Croydon-Kowloon Designs Ltd

Plot# 285-288, Dhaka EPZ (Extension Area), Ganakbari, Ashulia, Savar, Dhaka
(23.946883N, 90.274114E)

8th July 2019

Observation

Overall stability of the building

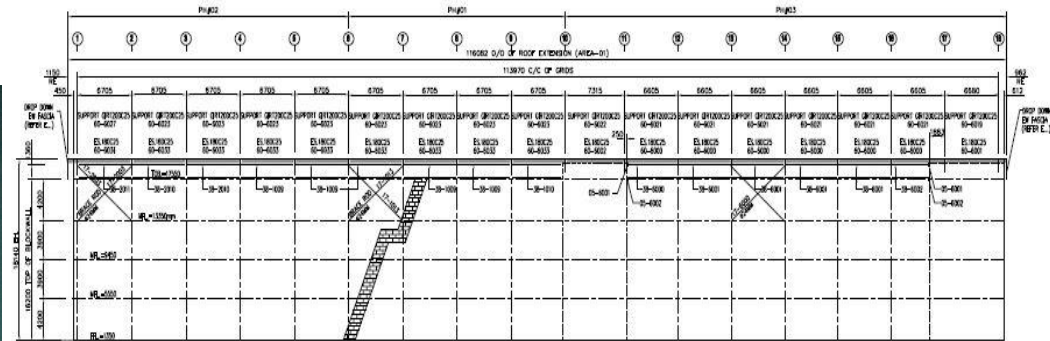
Partially fixed in N-S/ Short Direction

Pin/hinge Connection in E-W/ Long Direction

Pin/partially fixed Connection at beams and column joint connected by shear cleat and bolts. Apparently partial moment resisting frame action may govern that may affect the stability.

Building engineer is required to check the overall stability system and the connections.

NEAR SIDE WALL FRAMING ELEVATION (GRID LINE A)

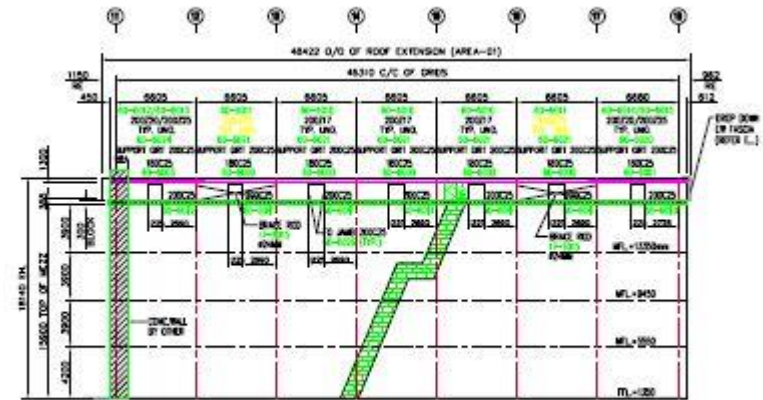
No vertical bracing/lateral load resting system in any long direction.

Vertical bracing only in 3rd floor of portal frame.

Column and RC wall layout plan

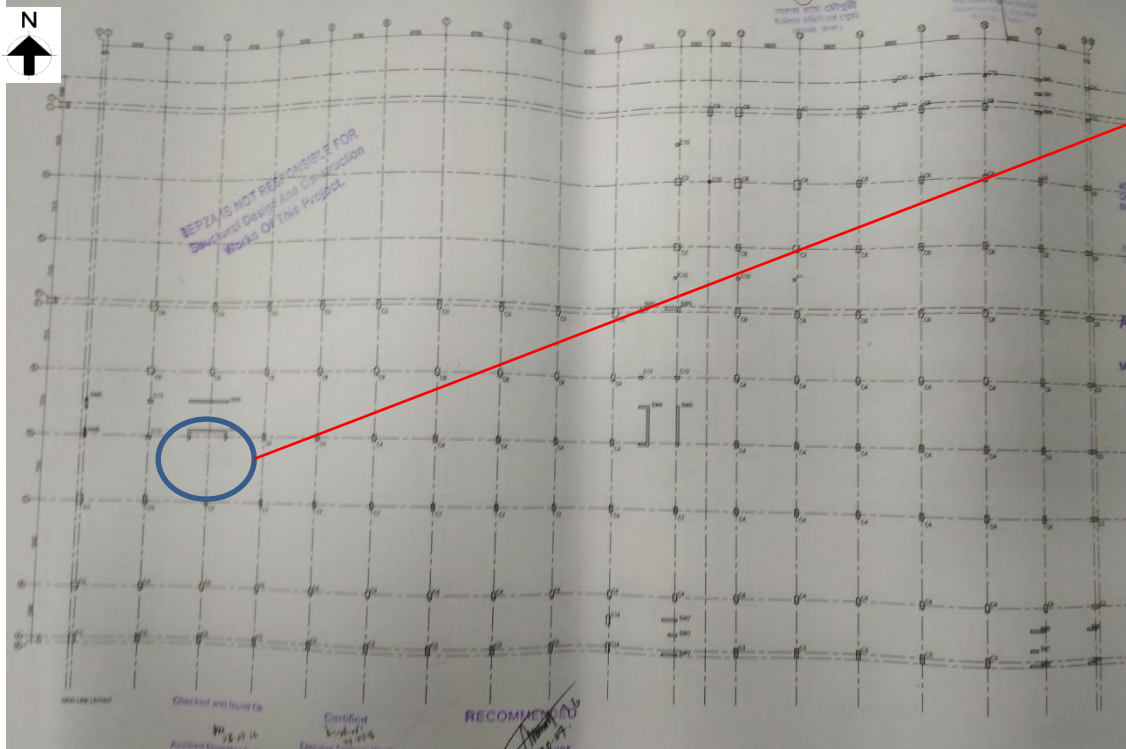
Steel beams in the several grids are connected to the RC walls. Design report was not available to determine the contribution of RC wall and diaphragm action in lateral stability system.

Ground floor column

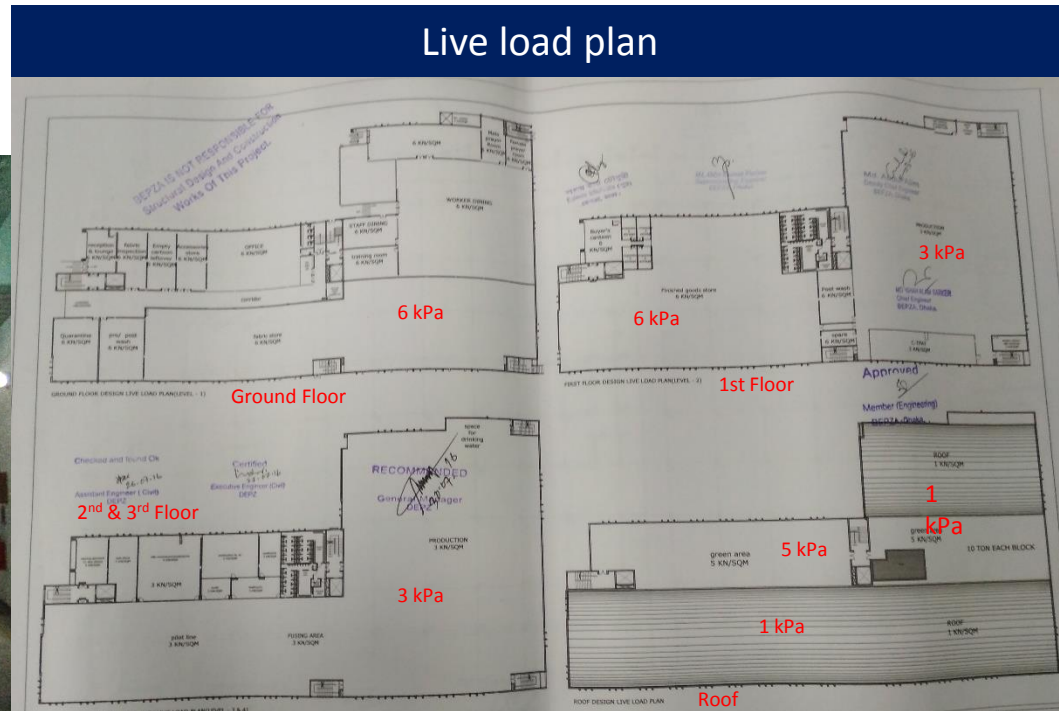
During inspection, steel plate test report was not available. Cursory calculation indicates that the working stress of ground floor steel columns (considering $f_y=248$ Mpa (36 ksi)) are above the normal design limits. However, calculation indicates that the working stress of ground floor steel columns are satisfactory by considering the $f_y=345$ MPa (50 ksi). Building engineer is required to carryout plate load test to confirm the steel grade and review the design based on the test report.

FAR SIDE WALL FRAMING ELEVATION (GRID LINE J)

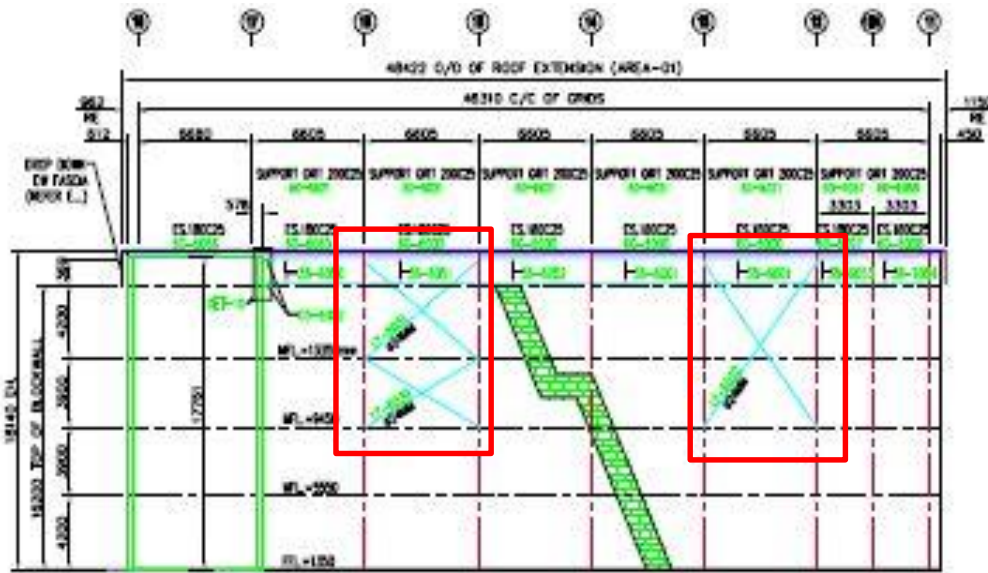
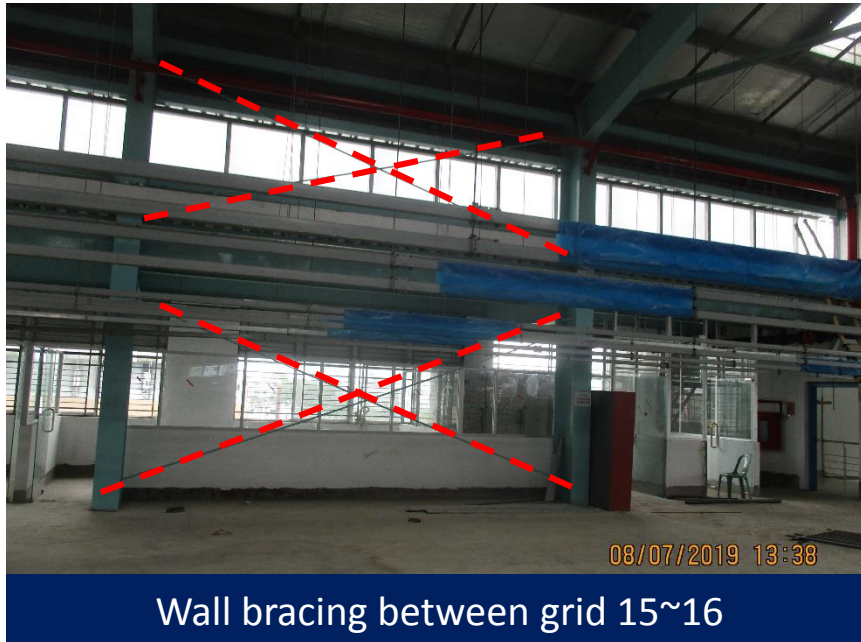
Wall bracing between in grid J-15~16 & 12~13 does not match with the onsite condition. This bracings were not found on 2nd floor.

Wall bracing between grid 15~16

Wall bracing between grid 12~13

Item No.	Observation	Recommended Action Plan	Recommended Timeline
6	Wall bracing plan at grid-J (Factory Building)	Review the bracing system as part of Engineering Assessment.	6-weeks
7	Wall bracing plan at grid-J (Factory Building)	Update the as-built drawings as per site condition.	6-weeks
8	Wall bracing plan at grid-J (Factory Building)	Carryout remedial works where necessary.	6-months
9	Column sizes not matched with site condition (Utility Building)	Building engineer is required to survey the structure and prepare as built drawings.	6-weeks
10	Missing floor beam and tie beam (Utility Building)	Install the missing floor and tie beams as part of the remedial scheme.	6-weeks

Missing floor beam and tie beam

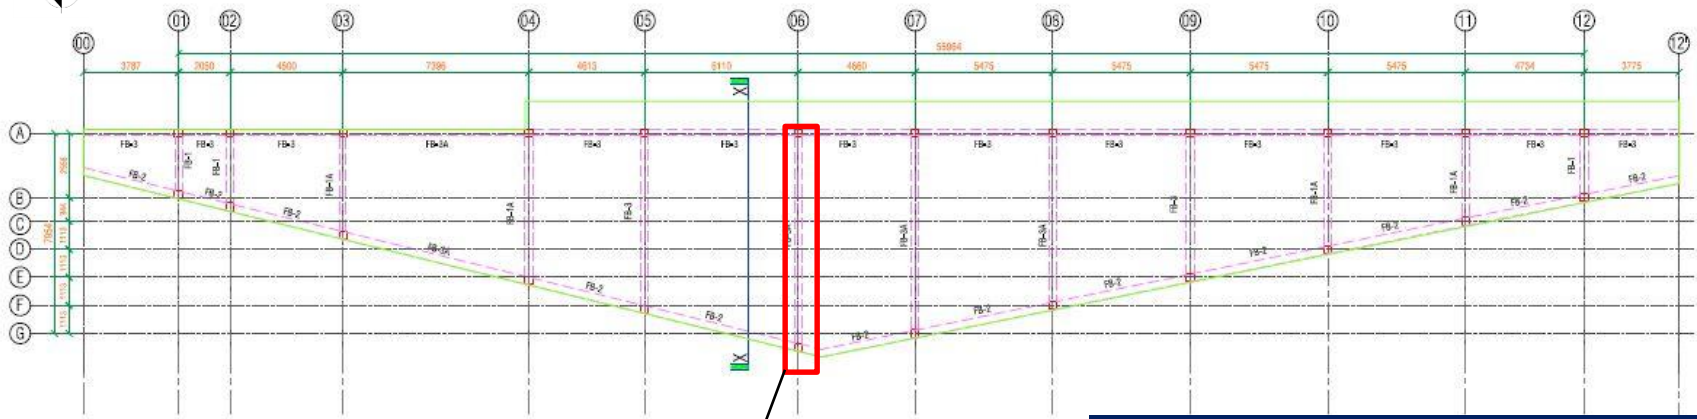
Tie beam missing

Floor beam missing

The missing beam makes the slab span of 10.2 m X 6.85m .
